## Product Change Notification

FIBRAIN Sp. z o.o. would like to inform about the design modification of fiber optic cables from the EAC group. Please note that the change relates to the position of the grooves in the cable sheath. The grooves have been offset from the reinforcement strength members by 90 degrees. According to the above, the line marked by the grooves indicates directly the place where the center of the window cutting tool should be placed in the cable. The described method of making the incision prevents from damaging strength members placed in the cable sheath.

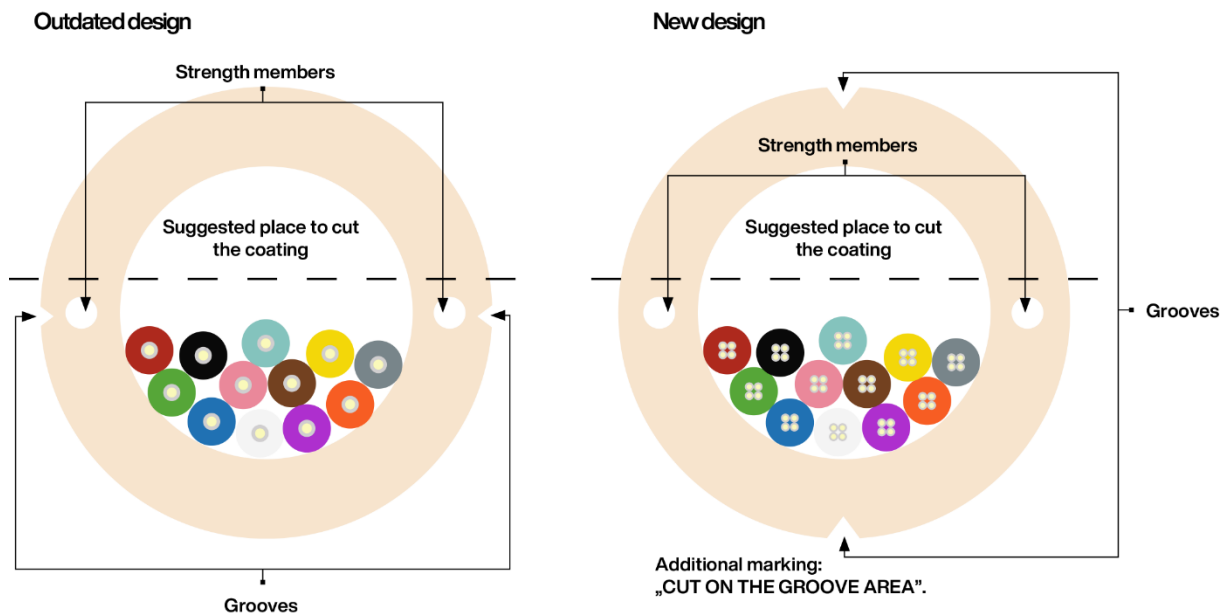
The cables with the modification are marked with an additional marking: "CUT ON THE GROOVE AREA".
